AAT April 28, 2005 – Keypad Scoring Results

Image Scores and Comments

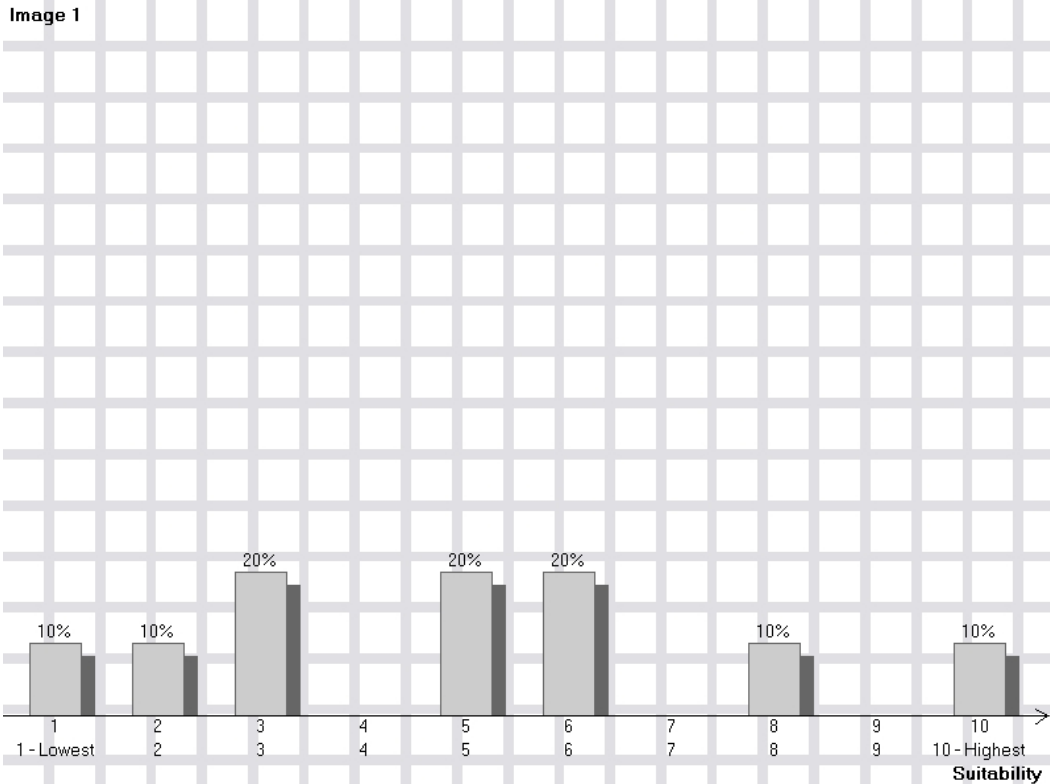
Item:	Image 1  Worried about the function of the sound barrier. Looks like a typical treatment seen around the area. Worry about 2 to 1 slope becoming overgrown, would like something that could be maintained. Rescue difficulties on a 2 to 1 slope. Not as elaborate so money can be saved. Needs aesthetics for such a visible project. Box culvert looks just like a box - not very pretty.																						
Scale:	1 Image 1 																						
Mean:	4.9																						
Median:	4.9																						
Std.Dev.:	2.60																						
Vote Details:	Image 1

Image 2

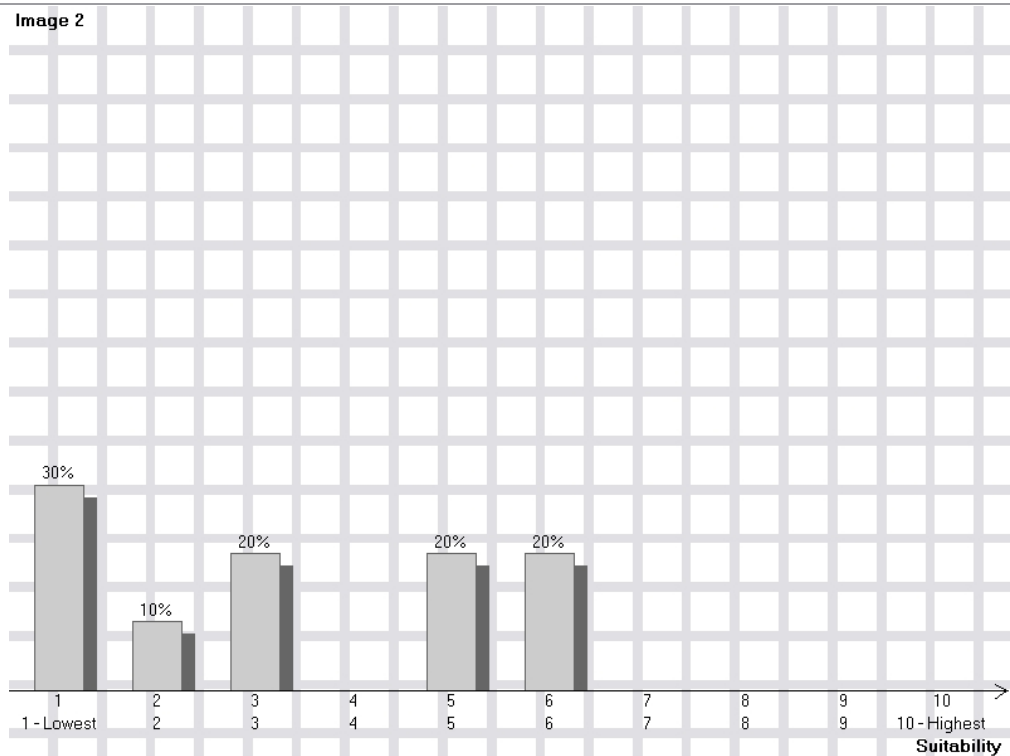
Concerned about the light fixtures sitting up.
Would be better to lower the light fixtures.
Light pollution doesn't fit into the environmental area.
Why don't all the sketches show the light fixtures as well?
Not aesthetically pleasing. Just blah.

Image 5

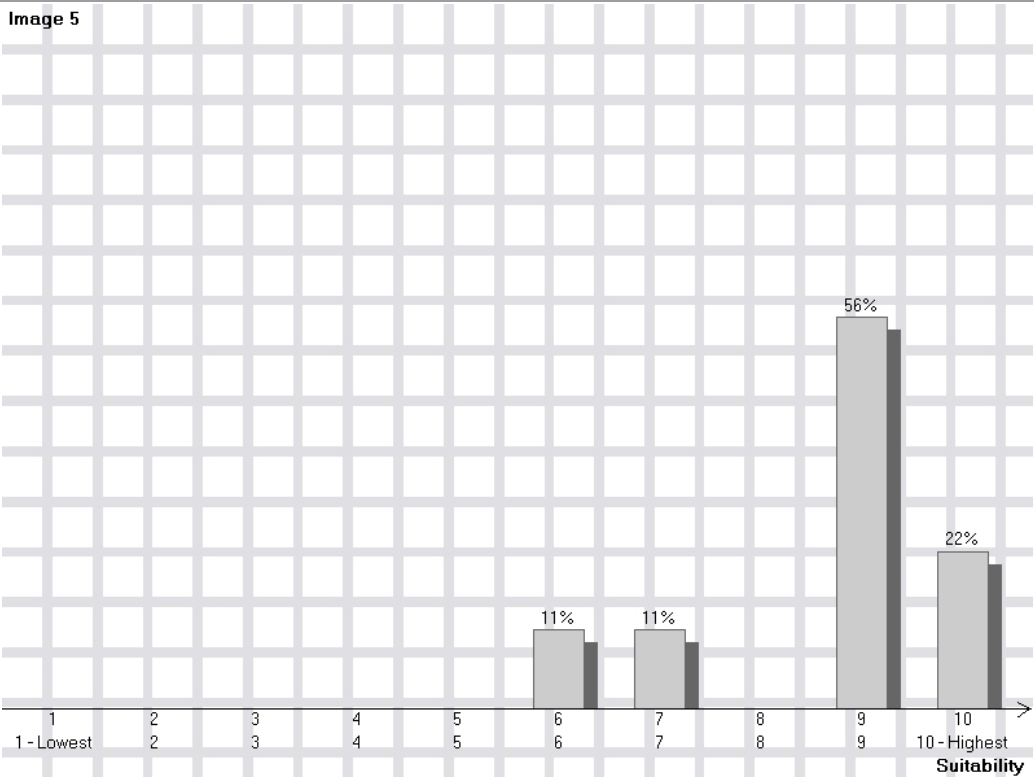
It has a more gentle sloping effect which will look better.
Like the idea that animals can move.
Away from road.
Most attractive of the concepts.
Can elements of B be combined with elements of C?
This blends in better with the character of the land.
Does this concept lend itself better to the construction of sound barriers?
Primarily sound would be my concern.
Hard to vote on these concepts without perspective from road also.

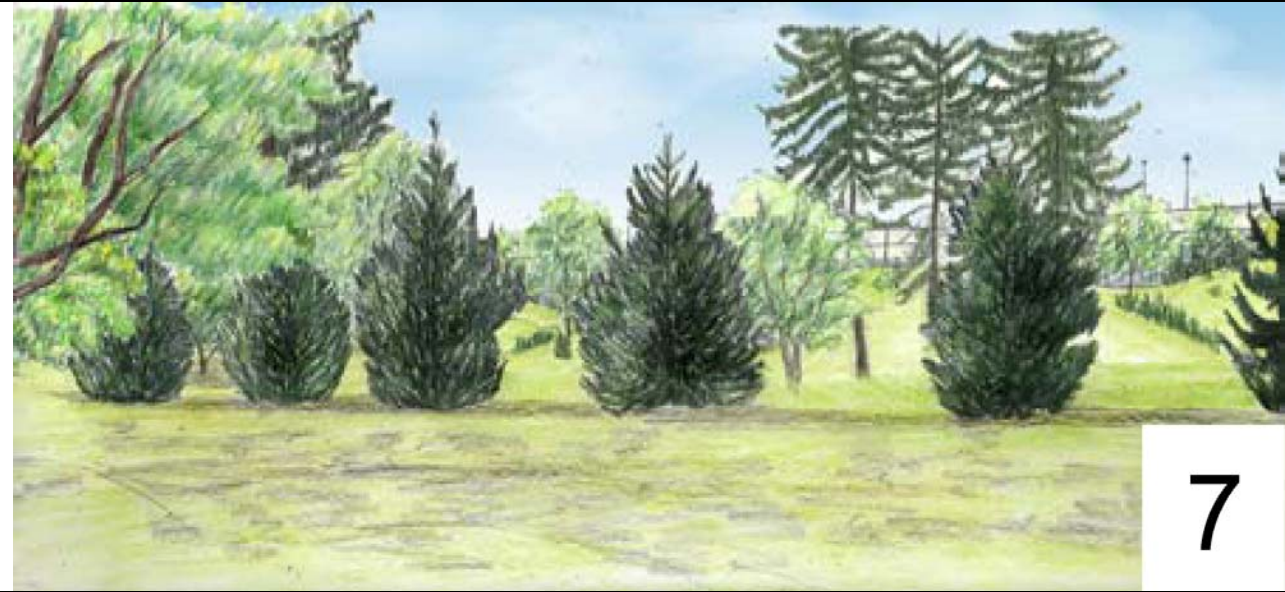
Item:	Image 6  100% better than Concept A. Breaks up landscape. More natural.										
Scale:											
Mean:	8.6										
Median:	8.7										
Std.Dev.:	1.10										
Vote Details:

Image 8

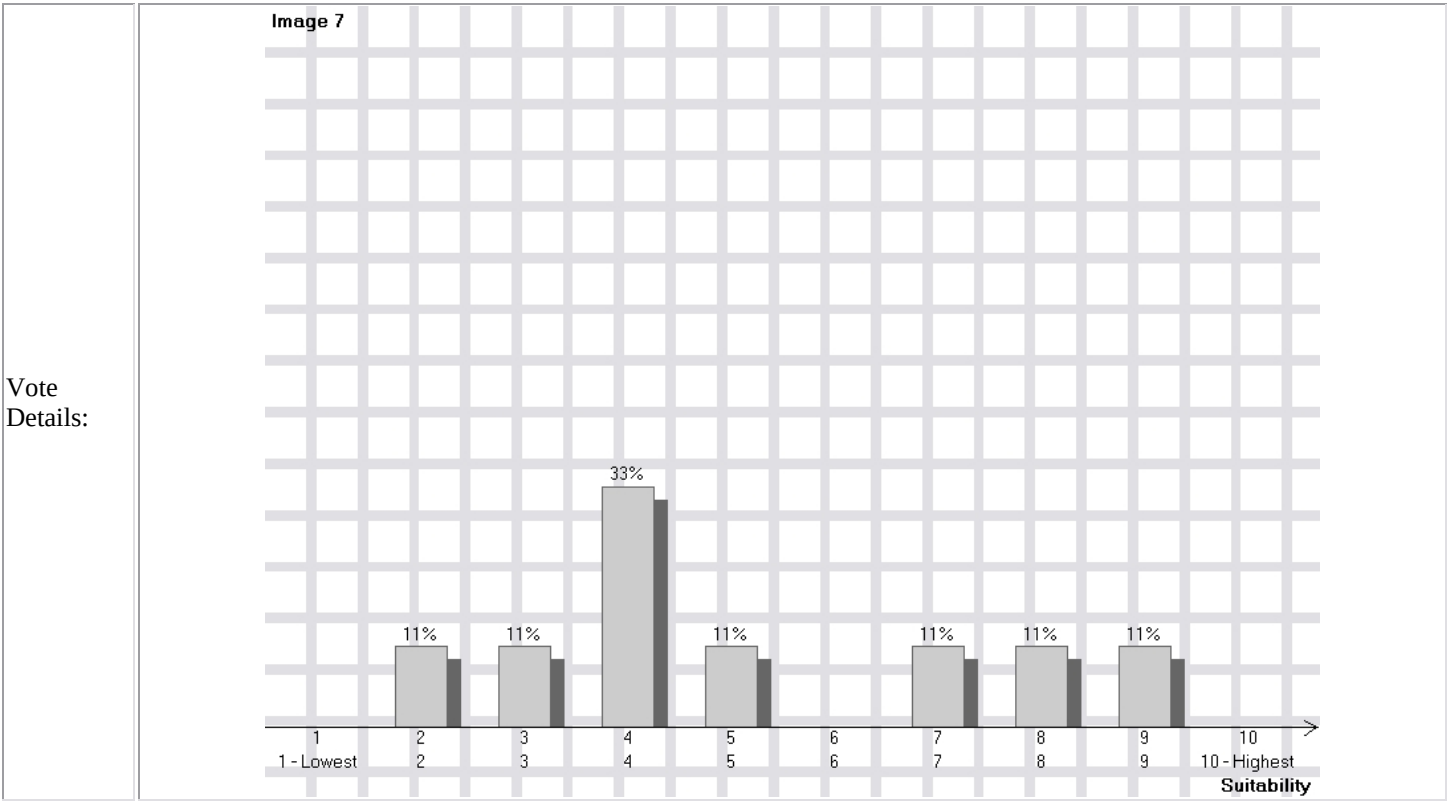
Doesn't seem to fit. (Bridge and retaining wall.)
Looks artificially done, injecting concrete or steel or whatever, stone, into the natural area.
How much space do the animals need?
So much of the creek stone retaining wall. (Out of scale)
Too contemporary.
Very noisy with all that concrete.
Not sure if open space is a good idea.
Doesn't have a rural feel. Just one landscape.
Structure is not aesthetically pleasing. Don't like the structure.
The retaining wall breaks up the uniform fill to an advantage.
Changes the sight lines of the fill. Hate to see a solid fill.
(Maybe at a smaller scale)

Image 9

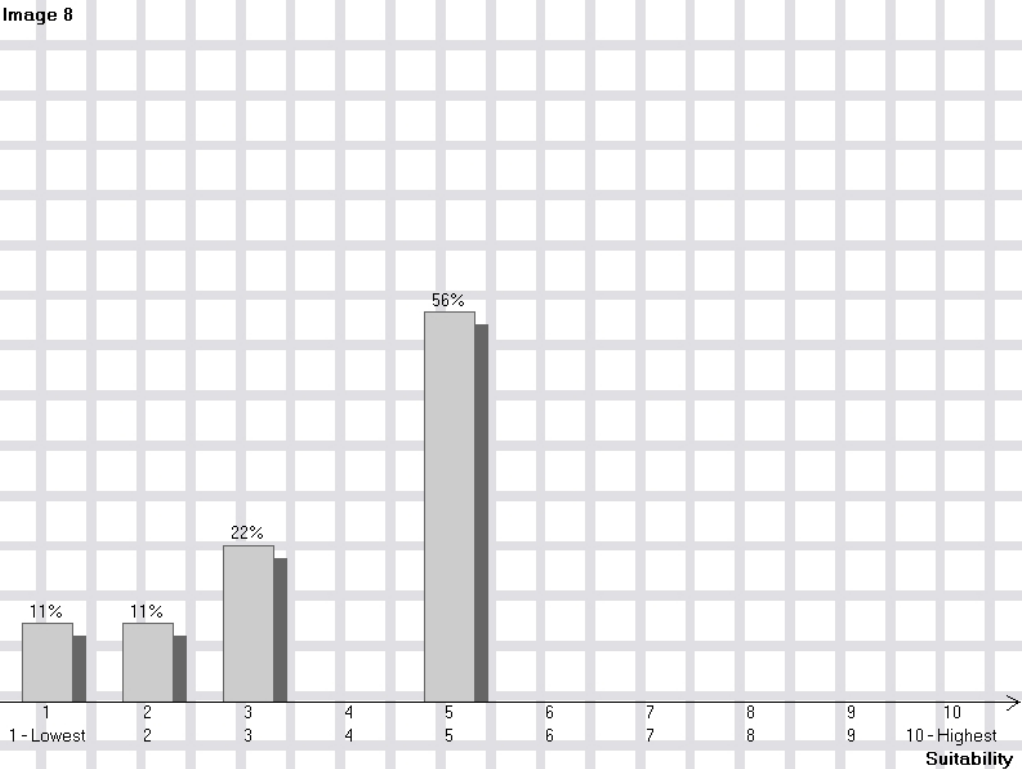
Is that a wood wall, stone?
Like it because it breaks up the landscape.
Looks natural.
You don't see the sound barrier.
Is there no light fixtures?
Like the fact that plantings can be closer to top of berm.
